3. Marysville 2023; KPB File 2023-106

Geovera, LLC / Emmitt & Mary Trimble Joint Revocable Trust

**ITEM #3 - PRELIMINARY PLAT
MARYSVILLE 2023**

KPB File No.	2023-106
Plat Committee Meeting:	November 13, 2023
Applicant / Owner:	Emmitt and Mary Trimble Joint Revocable Trust of Anchor Point, Alaska
Surveyor:	Stephen Smith / Geovera, LLC
General Location:	Anchor Point / Anchor Point APC

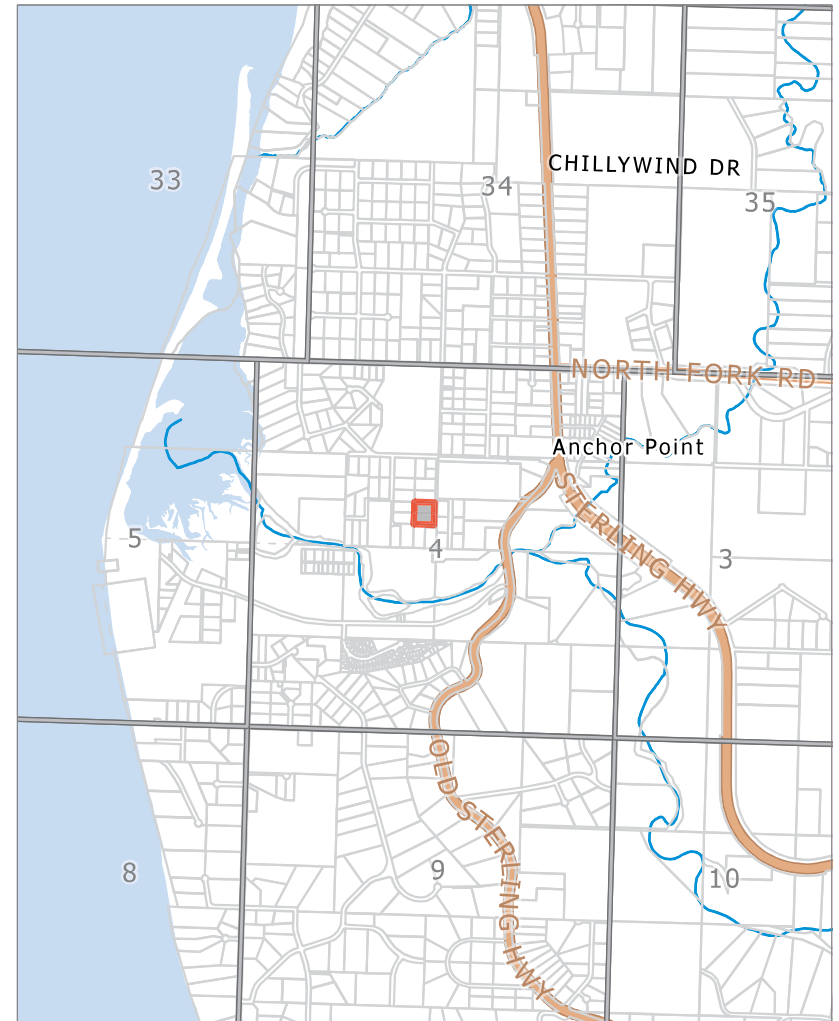
Comments: Birch St will not qualify for maintenance without additional dedication and alignment corrections. If resolved, it would be positive to see the plat granted turnaround easement formally dedicated.
SOA DOT comments	No comment

There are no classified wetlands, the plat note regarding wetland determination is present and can remain. The area is in a flood hazard area as designated by FEMA maps and noted by the River Center below, appropriate plat notes for flood hazard should be added.

- Add KPB No 2023-106 to title block.
- *Correct the numbering of the plat notes.*
- *Add a distance on the back of Lot 8B.*
- *Add the meeting date of November 13th, 2023 to the Plat Approval.*
- *Reference plat in the legend should be HM 2007-9.*

- D. A vicinity map, drawn to scale showing location of proposed subdivision, north arrow if different from plat orientation, township and range, section lines, roads, political boundaries, and prominent natural and manmade features, such as shorelines or streams;
Staff recommendation: *Add labels for Anchor Point Road and Old Sterling highway. It could also be beneficial to reduce the visible area.*
